How about add a “Laser Control”  
into Discovery Proccesing State diagram.

Yasuo Ogura

NTT

## Problem : Collision in the Discovery window

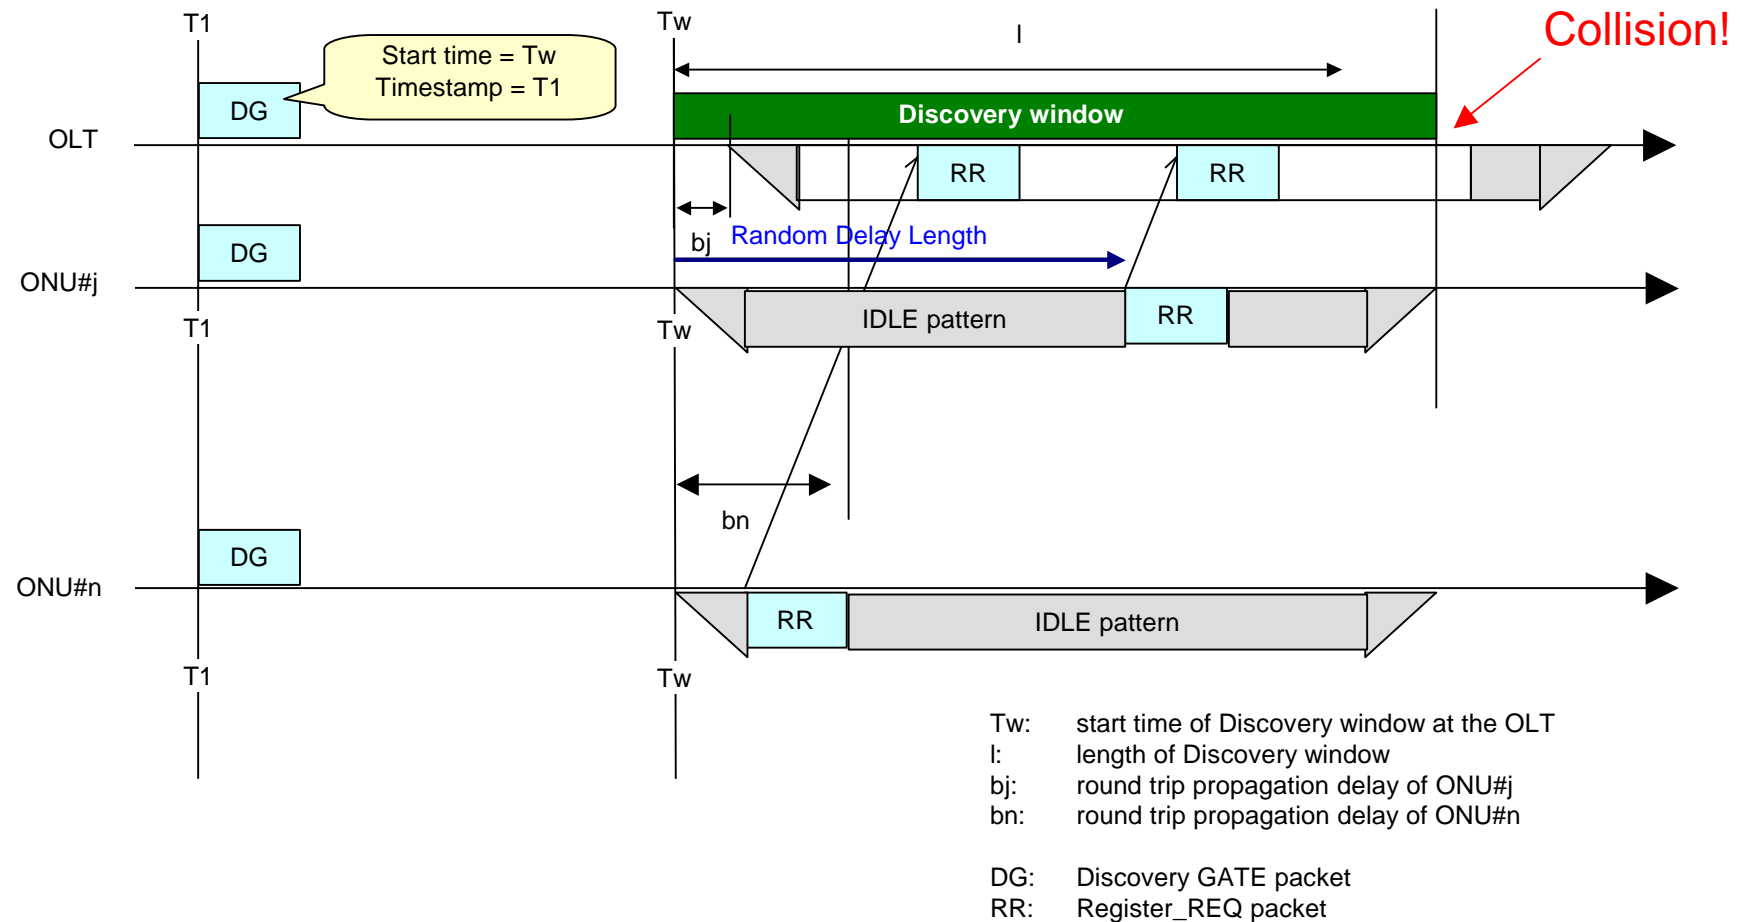
There is no relationship between "Gate Processing" and "Report Processing", so that Laser will be ON/OFF independent to send Register\_REQ or not.

ONU#j and ONU#n turn Laser ON at the same time, collision will happen in the Discovery window. It seems difficult to process AutoDiscovery successfully when multiple ONUs are power ON.

## Solution:Laser ON/OFF during Register\_REQ

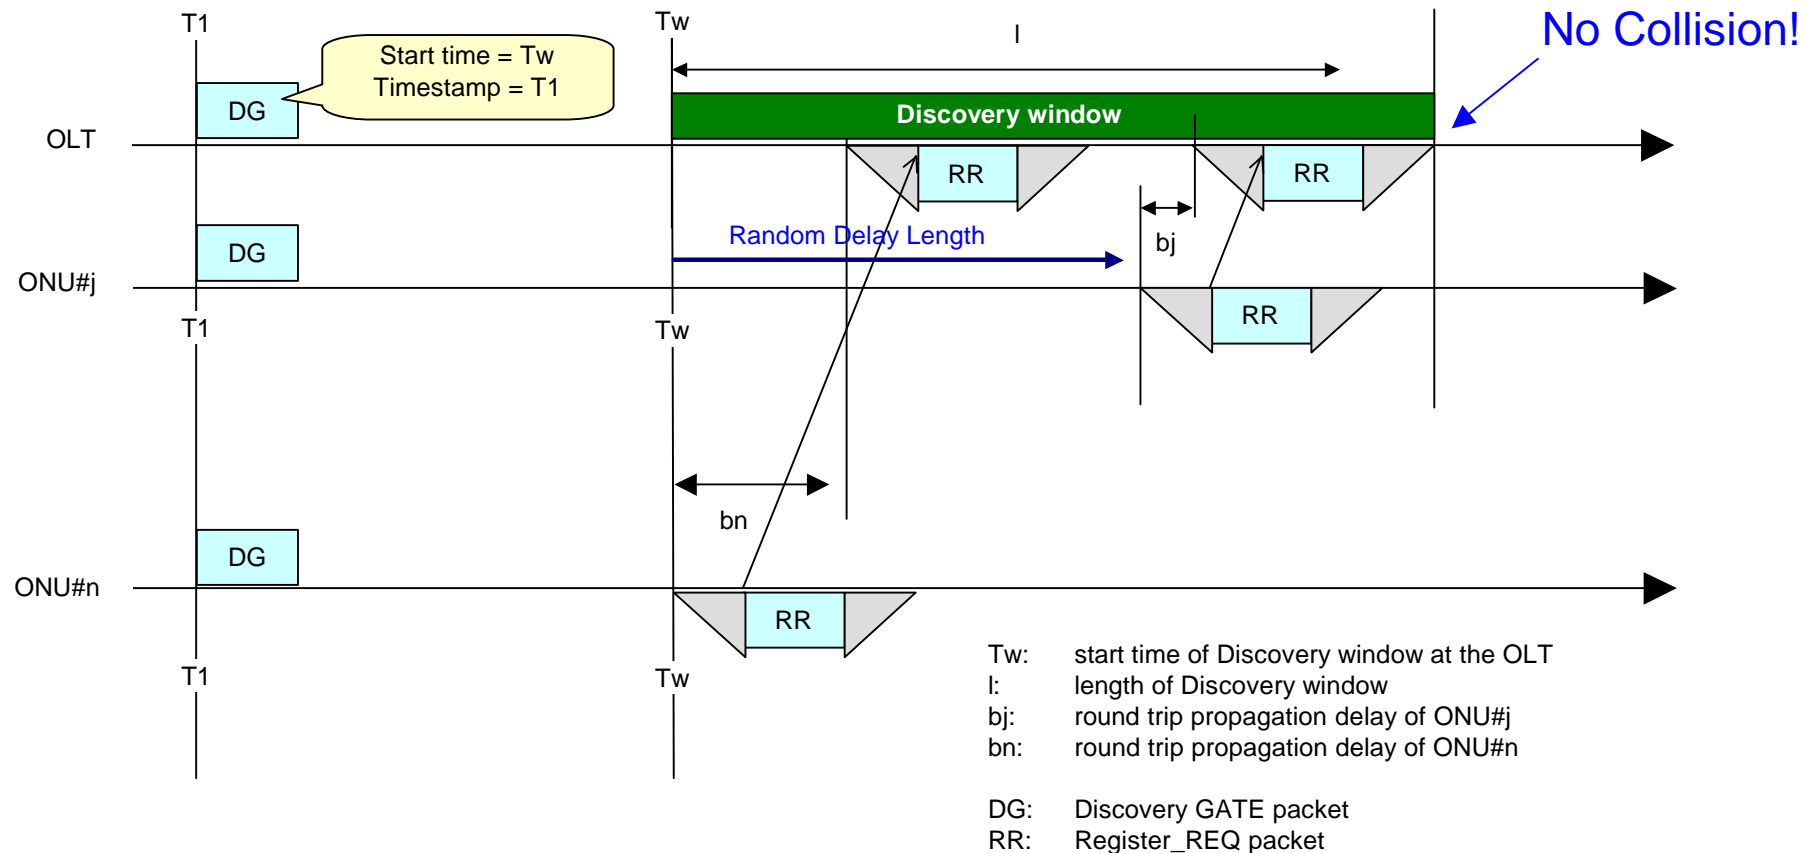
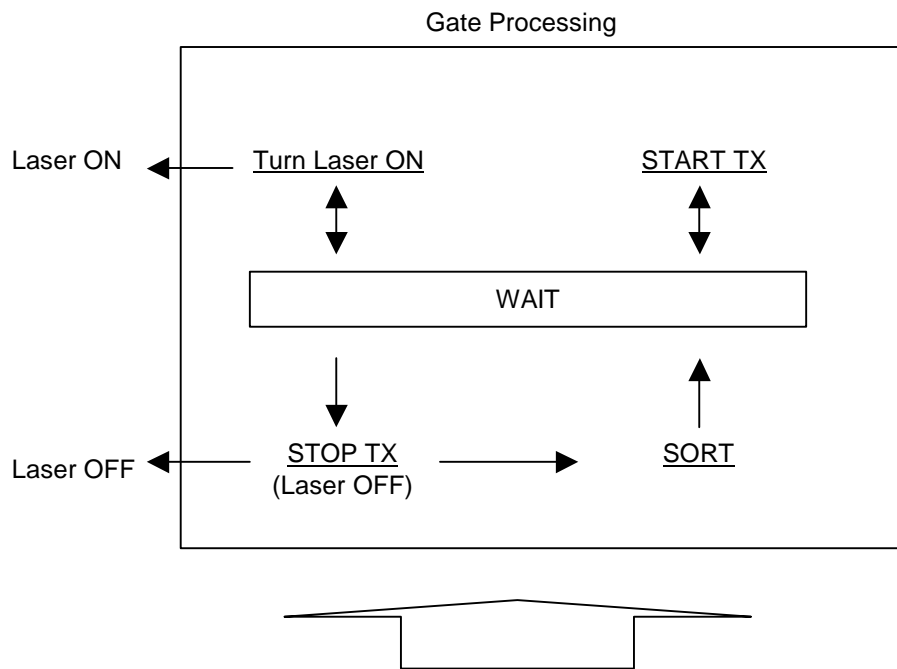
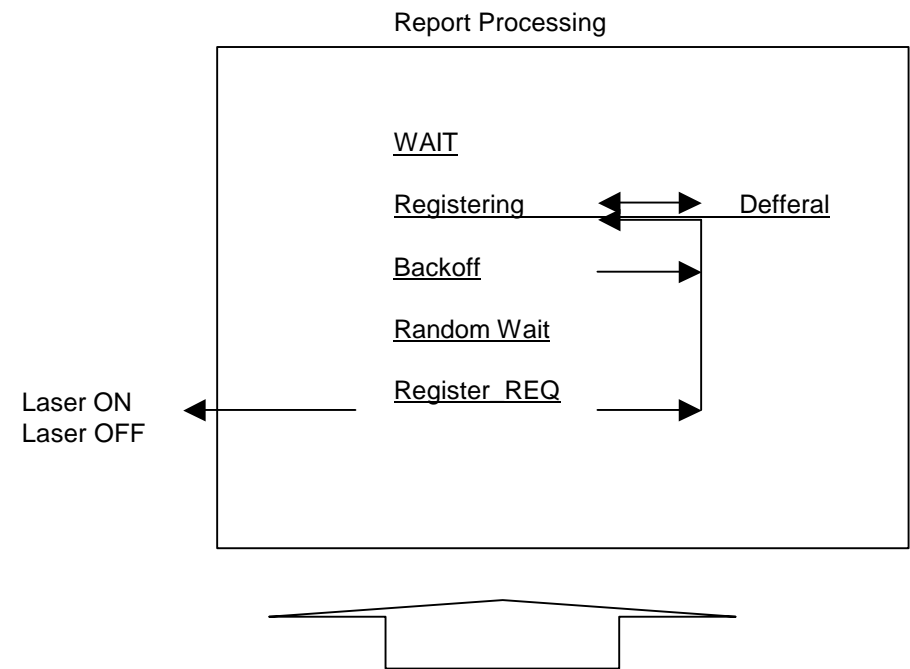
How about turn laser ON while ONU is sending a Register\_REQ only?  
It seems easy that OLT receive multiple Register\_REQ in a single Discovery Window.

NormalGATE : Gate Processing control "Laser ON/OFF" .  
 DiscoveryGATE: Discovery Processing should control.

Report Processing decide to send REGISTER\_REQ MPCPDU and control Laser ON/OFF at the same time.

ONU decide to send Register\_REQ or not in the Discovery Processing,

In the Discovery Processing, ONU should contol Laser ON/OFF.  
 In the Gate Processing, only Normal GATE will be processed.

Figure 56-13—OMP Parser/Multiplexer RX State Diagram

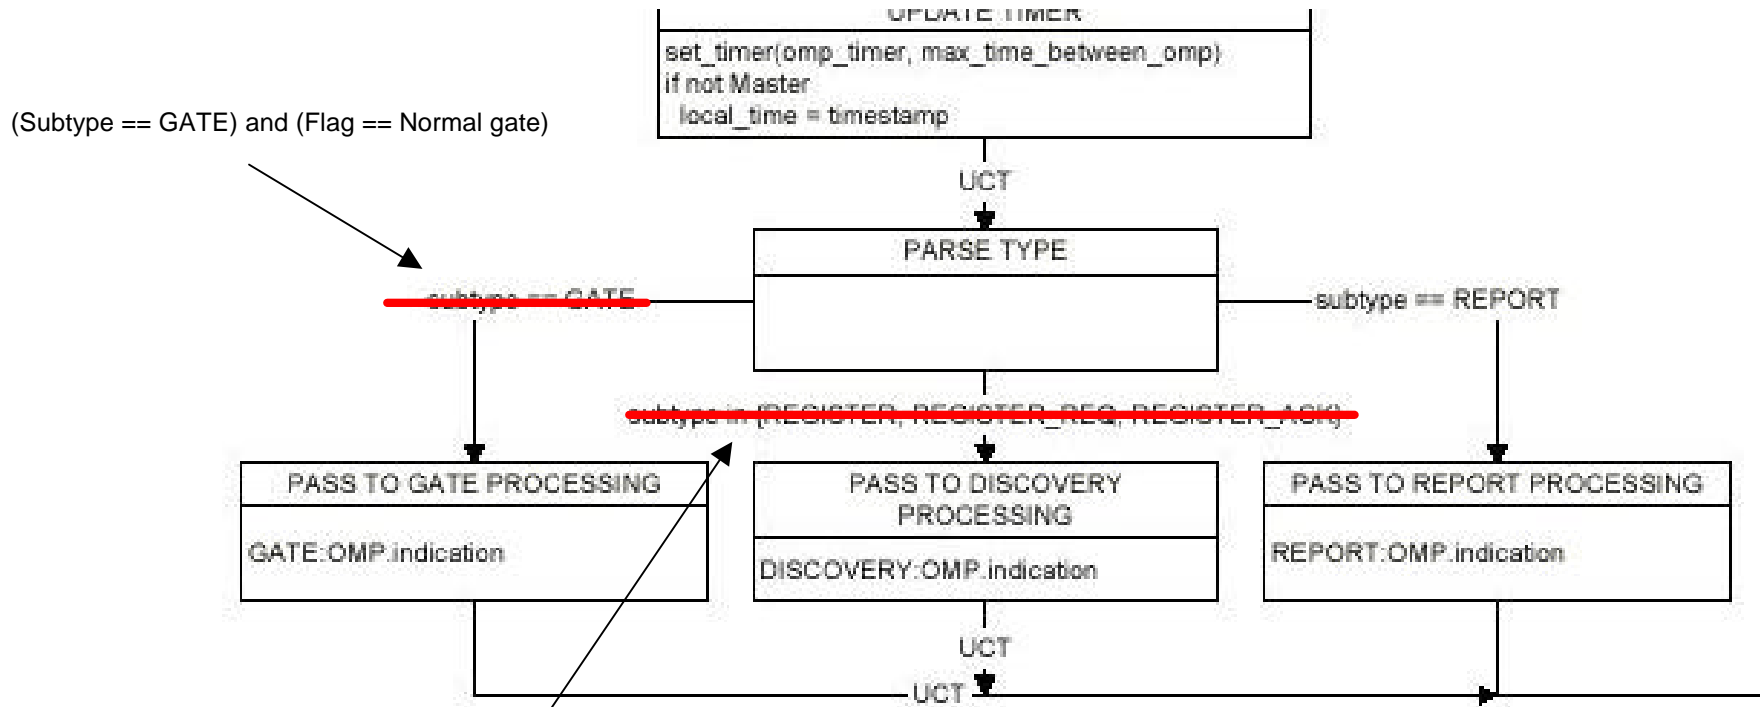
# Proposal1 : OMP Parser/Multiplexer RX State Diagram

P.126 56.3.3.1.6

(subtype in { REGISTER, REGISTER\_REQ, REGISTER\_ACK})  
or  
(Subtype == GATE) and (Flag == Discovery gate)

### Figure 56-17—Discovery Processing Slave

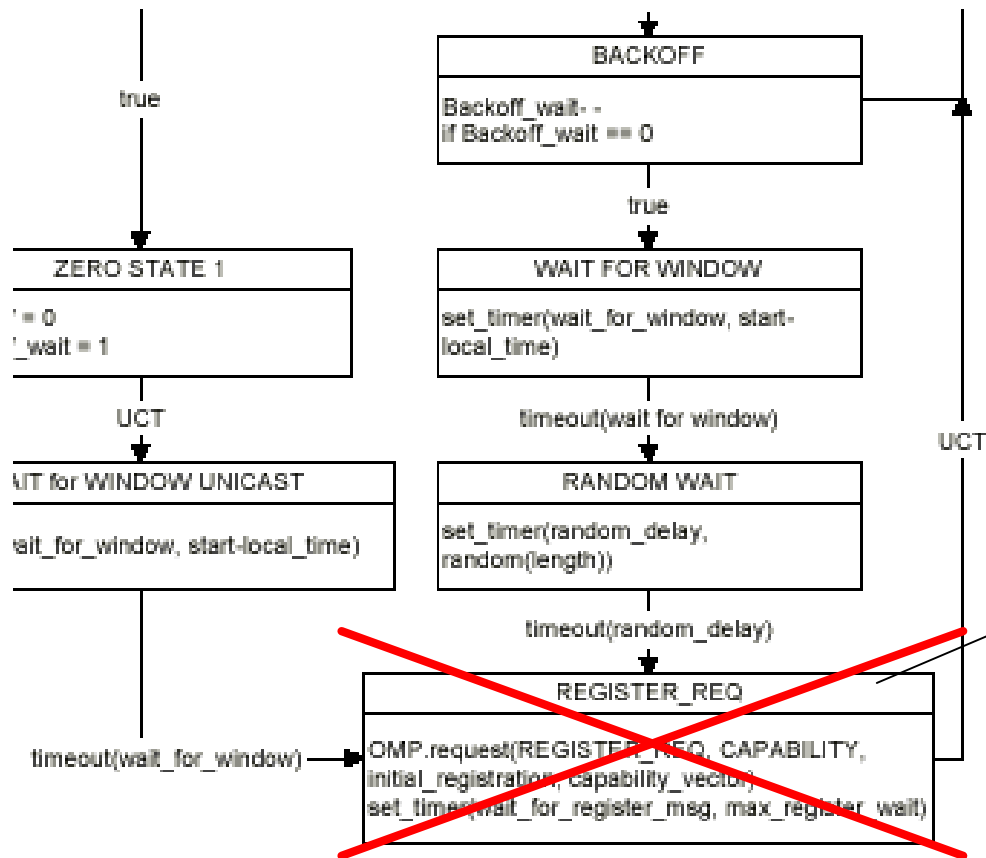
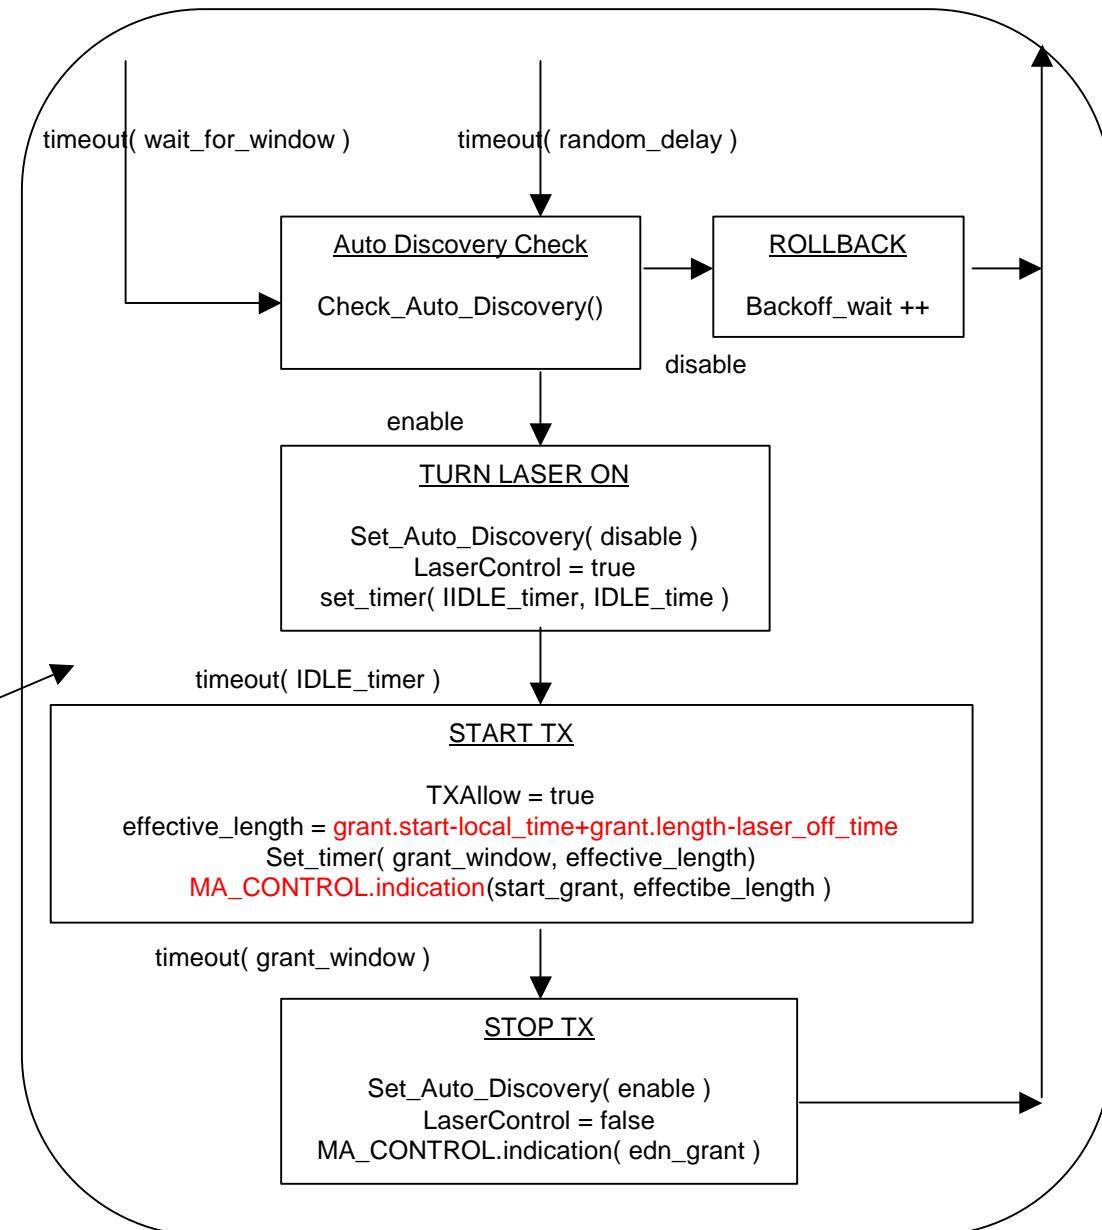
## Proposal2 : Discovery Processing Slave State Diagram 1

## P.135 56.3.4.1.6 State Diagram
